Section 16 Planning Application in Support of Proposed Minor Relaxation of Plot Ratio Restriction for Proposed Hotel Use at Chai Wan Inland Lots 12 and 43, 14 - 16 Lee Chung Street, Chai Wan, Hong Kong (Application No. A/H20/202)

Reference is made to the captioned Planning Application submitted to the Town Planning Board (the Board) on 11 September 2025. In response to the verbal comments from District Planning Office / Hong Kong (DPO/HK) on 8 October 2025, the Applicant would like to provide the clarifications below to substantiate the captioned planning application.

Indicative 1/F Plan

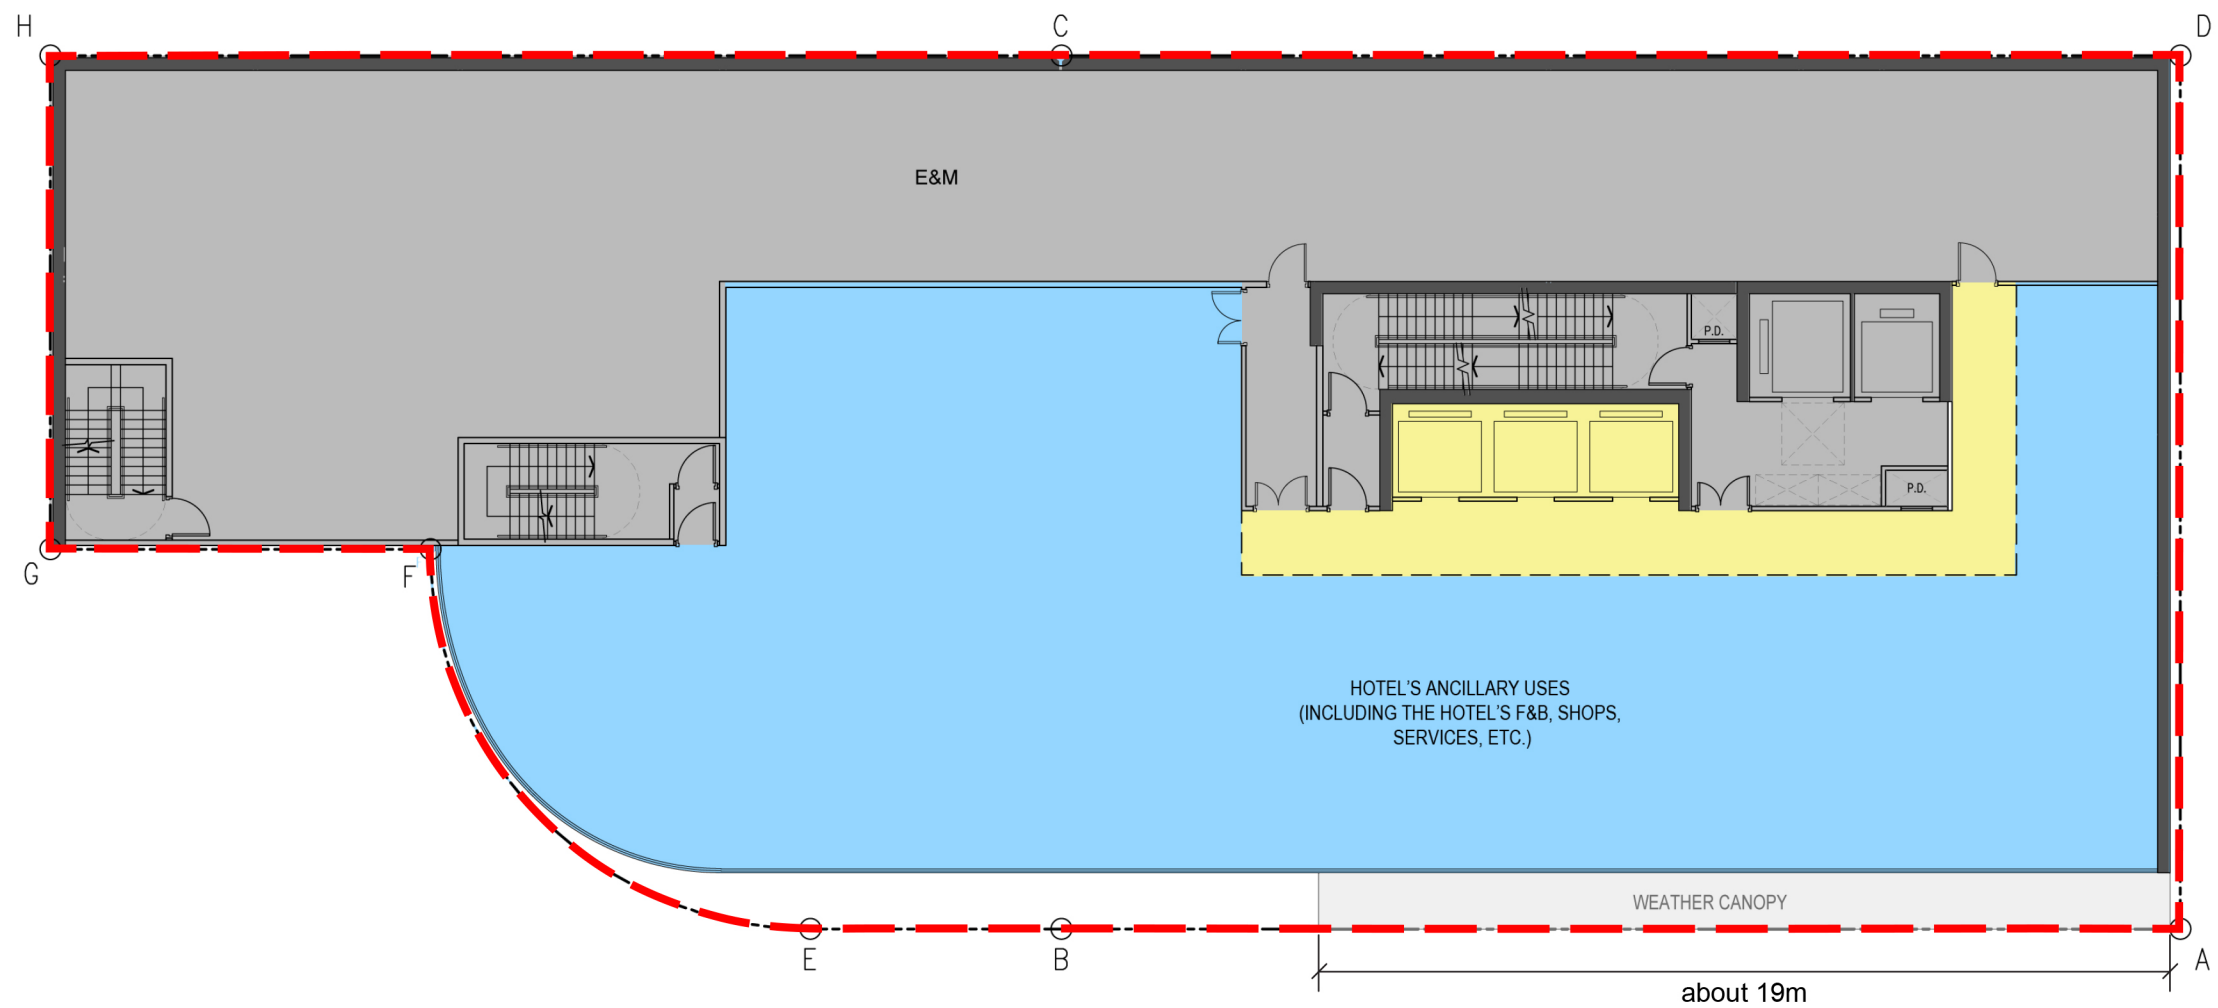
The configuration and the extent of the proposed weather canopy under the Proposed Scheme under the subject S16 planning application will remain unchanged as per the previous approved scheme (i.e. S16 Application No. A/H20/195) of about 19m long. Please note that the extent, height and projection of the proposed weather canopy will be subject to further review taking into consideration the requirements as stipulated under Building (Planning) Regulations (B(P)R) at subsequent detailed design stage for approval of relevant Government departments. For details, please refer to the enclosed updated **Figure 3.3 – Illustrative 1/F Plan** and updated **Figure 3.9 - Illustrative Plan showing Planning Design Merits**.

The extent, height and projection of the proposed weather canopy will be subject to further review taking into consideration the requirements as stipulated under Building (Planning) Regulations (B(P)R) at subsequent detailed design stage for approval of relevant Government departments
